STAFF RECOMMENDATION 1404 Cedar Lane November 15, 2017

Application: New construction- addition and outbuilding
District: Belmont-Hillsboro Neighborhood Conservation Zoning Overlay
Council District: 18
Map and Parcel Number: 11704030200
Applicant: Van Pond, architect
Project Lead: jenny.warren@nashville.gov

Figure 3: West elevation. Windows in box are to be enlarged

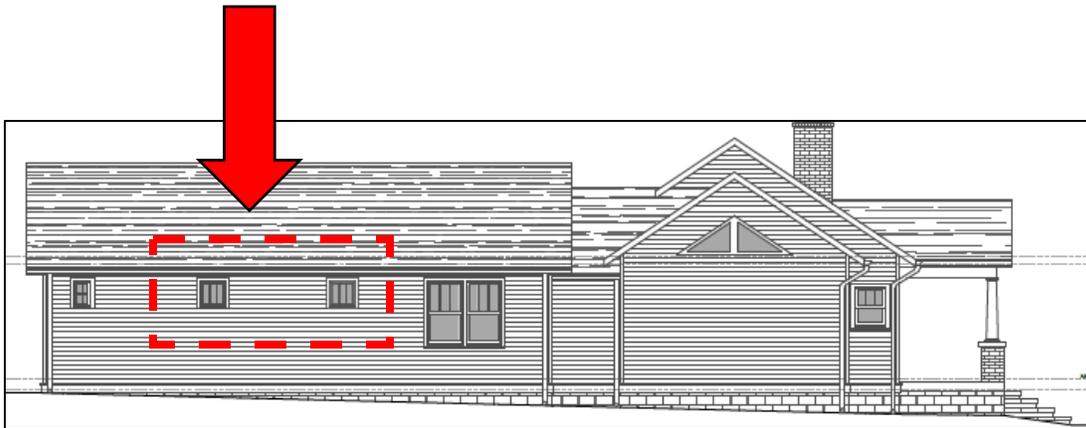
Demolition: The applicant proposes to increase the size of two small windows on the west elevation (see Figure 3), which is considered partial demolition. Staff finds that the increase in window size is appropriate, because the subject windows are located beyond the mid-point of the house. Further, the existing windows themselves are part of a non-historic prior addition, constructed post-1951. As such, the removal of the existing windows, and small portions of the existing side wall, will not destroy any historic material.

Proportion and Rhythm of Openings: On the west elevation, the applicant proposes to enlarge two existing small windows, such that they match the size of the other windows on the elevation. Staff finds this change to be appropriate, as discussed above, under 'Demolition'. Also found to be appropriate were changes to the rear elevation and the

Figure 5: Second story floor plan. Dashed line indicates Staff's proposed relocation of the exterior wall.

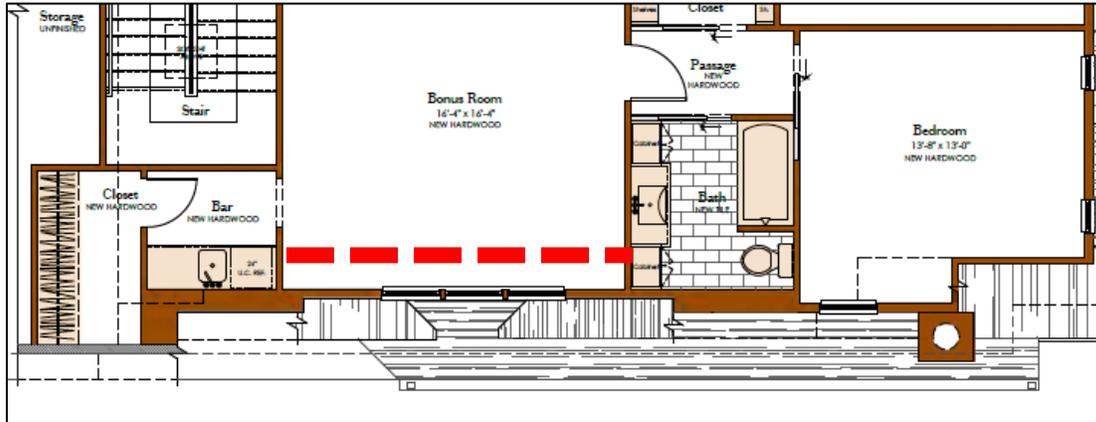
However, on the east elevation, Staff finds that the more significant increase in height creates the appearance of a full two-story structure and uses an inappropriate low-sloped roof form, which is not appropriate to the scale and form of the one-story historic house. Staff has worked with the applicant to minimize the visual impact of the second story and this revised elevation does show improvement. However, Staff finds that the massing of the second level is still overwhelming to the structure. As viewed from the east, the ridge raise and the added side gable both step back two feet (2') from the primary roof ridge. The section of wall connecting them (containing the triple windows) is the bonus room and is recessed six inches (6") further. Staff requests that this section of wall be recessed

a full two feet (2') to help break up the massing along this elevation and to further subordinate the second level (Figures 5 and 6).

With the condition that the wall of the Bonus Room be recessed two feet, Staff finds that the project meets section II.B.2.a and f.

1. The side wall of the second floor bonus room shall be inset two feet (2'), rather than six inches (6")
2. Staff approve the final details, dimensions and materials of windows and doors prior to purchase and installation; and,
3. Staff approve the roof color and foundation material.
4. The HVAC shall be located on the rear façade, or on a side façade beyond the midpoint of the house

Figure 6: Outlined area is the portion recommended to step back at least two feet (2') in order to lessen visibility of the inappropriate roof form.

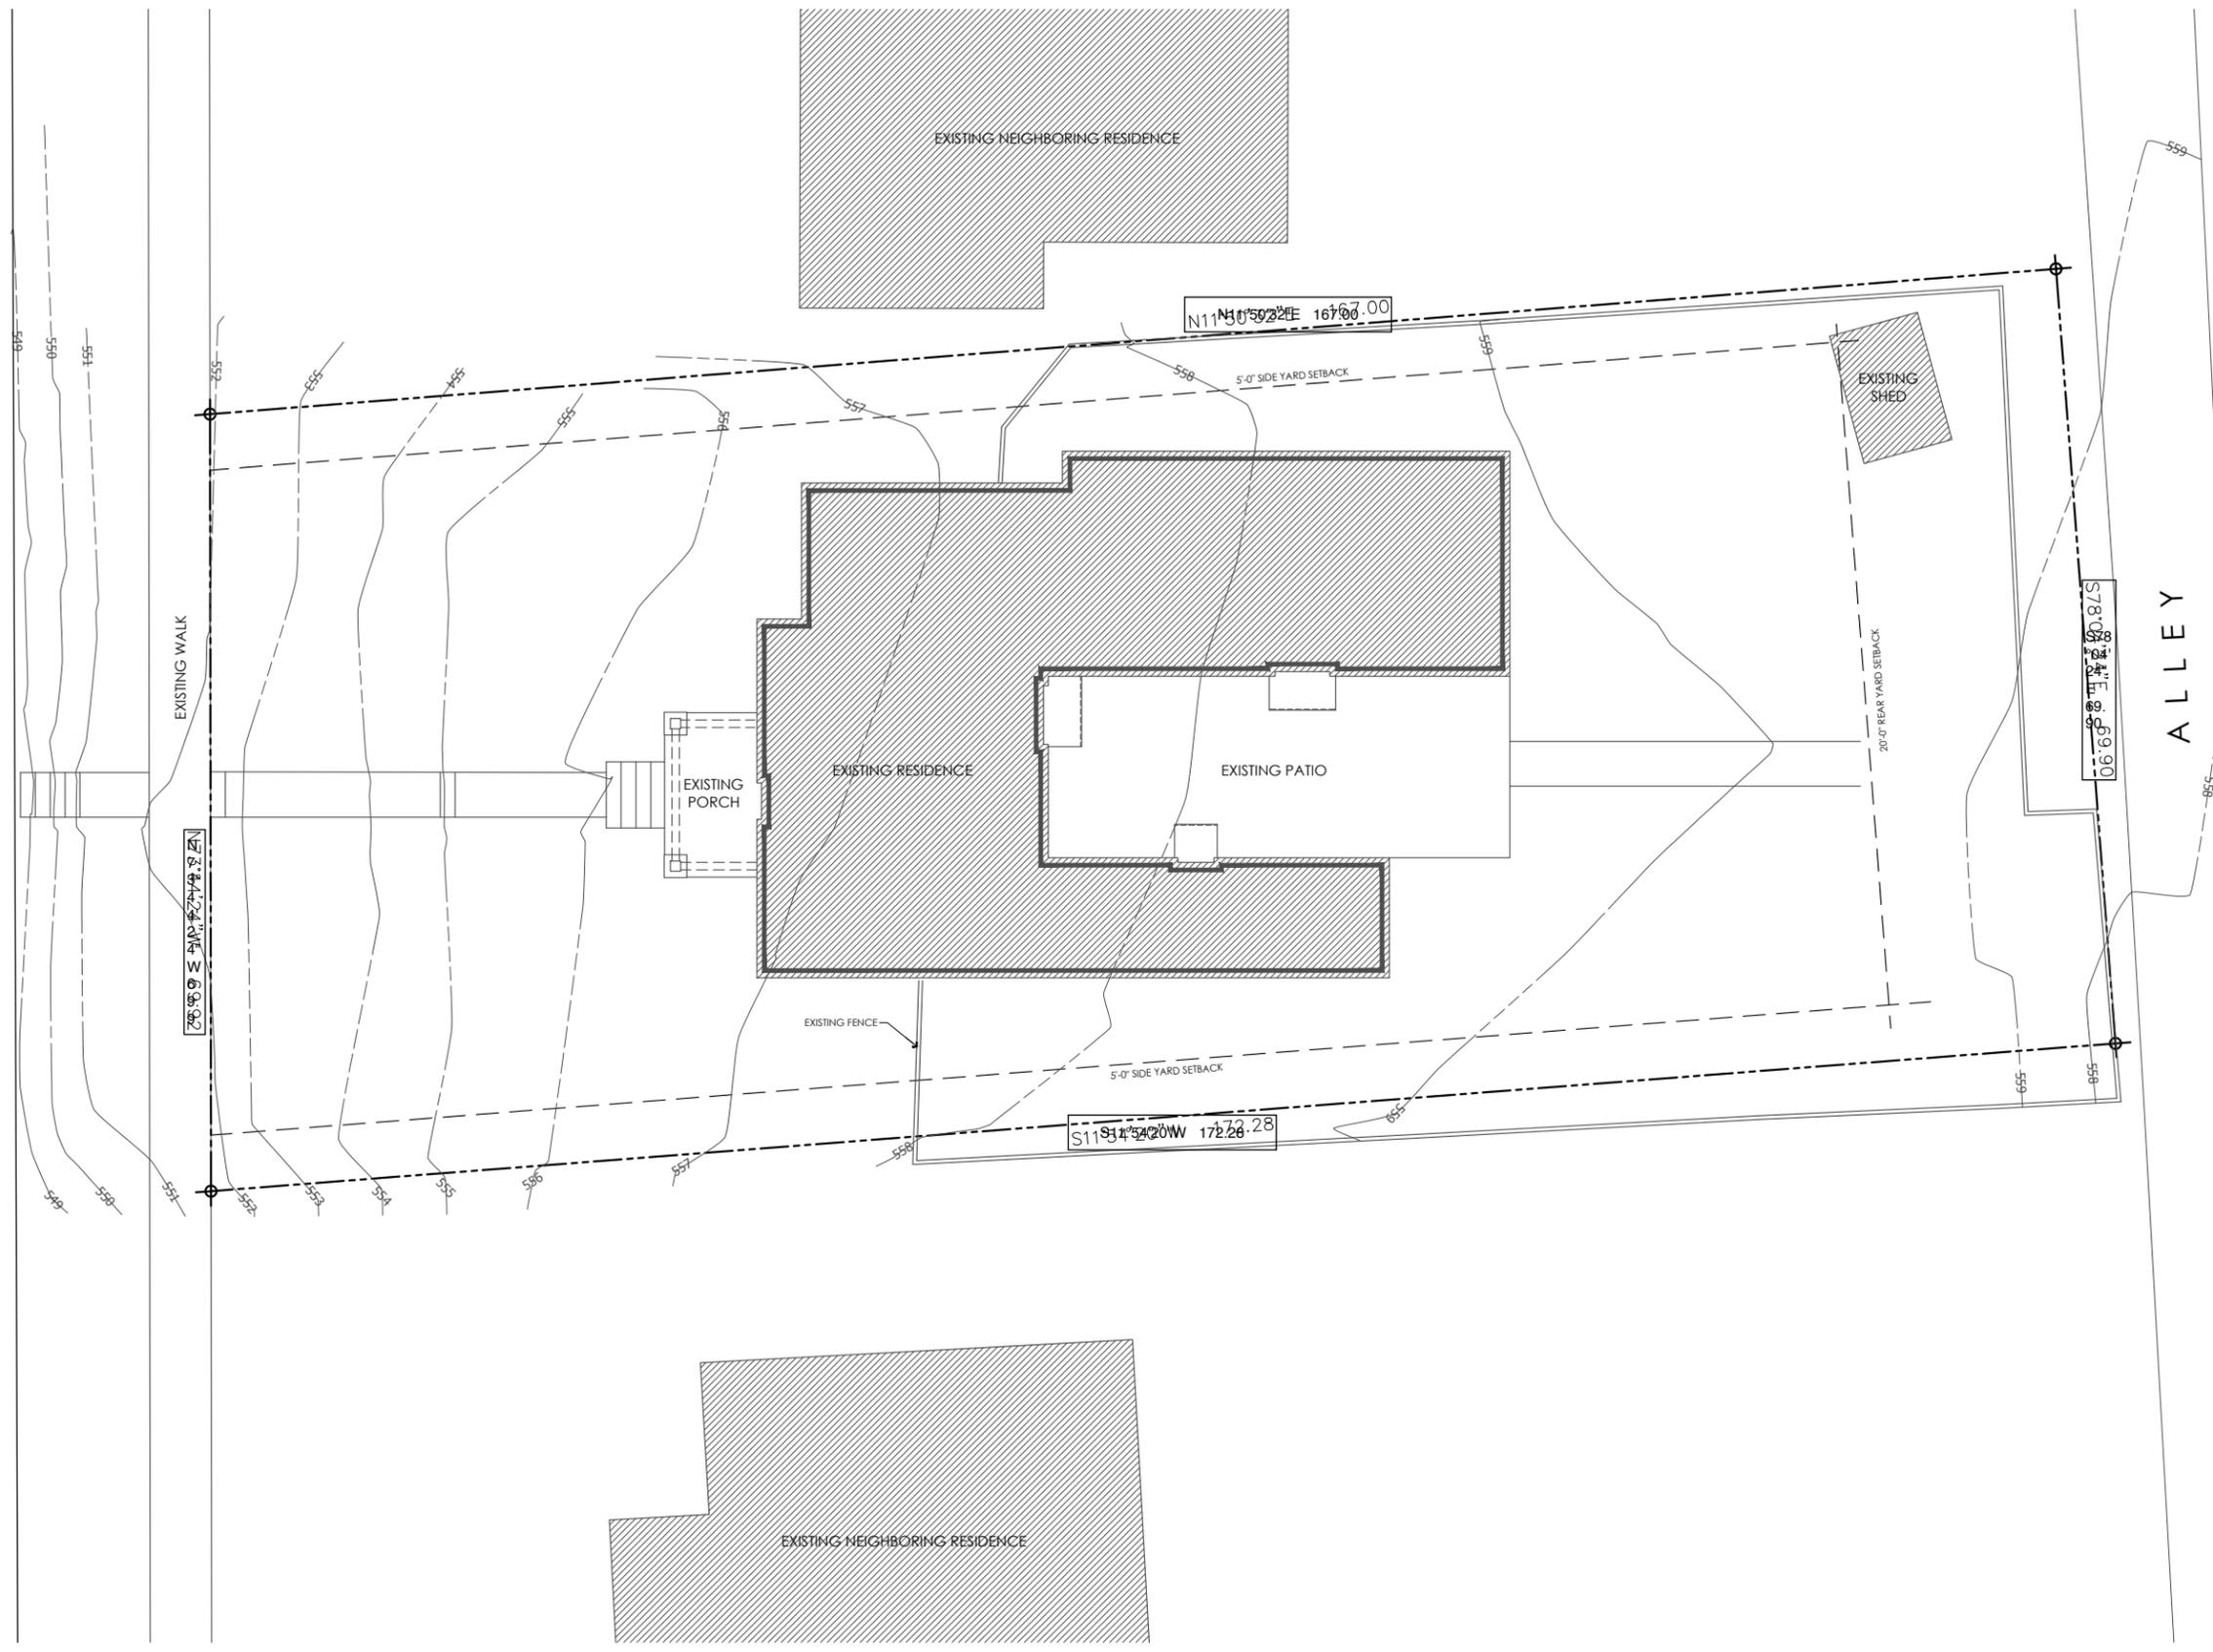
Roof form: The original house has a ridge height of approximately eighteen feet (18') from the finished floor height. The roof is side gabled, with a slope of 8/12. The two prior rear wing additions are both rear-gabled. The addition will include a ridge raise, which will be two feet (2') higher than the original ridge height, at twenty feet (20') above the finished floor height and will be inset two feet (2') on either side, meeting the requirements for a ridge-raise. This side gabled ridge raise will also have an 8/12 slope. A second side gable is proposed about forty-six feet (46') back. This ridge will span the existing rear addition wings and will be twenty feet (20') high, with the same 8/12 slope. It will project approximately five feet (5') wider than the original roof form on the west side, so that it can tie into the roofline of the existing addition. As stated above, Staff finds this to be appropriate, because only a small portion of this roof will be visible and because it is set so far back. The ridge raise and the side gabled addition will be connected by a very low-sloped perpendicular ridge with a slope of 1.25/12. Low-sloped roofs such as this are not commonly seen in the Belmont-Hillsboro neighborhood, but with the condition that this portion step back two-feet (2') from the sidewall, Staff finds it to be appropriate due to the unobtrusive location. A shed dormer off the rear will be inset two feet (2') from the east and more than eight feet (8') from the west. The screen porch addition will continue the rear-facing gable roof on the existing east wing addition.

With the condition that the bonus room wall be stepped back two feet (2'), Staff finds all of these roof forms and slopes to be compatible with the character of the house and the neighborhood. The project meets section II.B.1.e for roof shape.
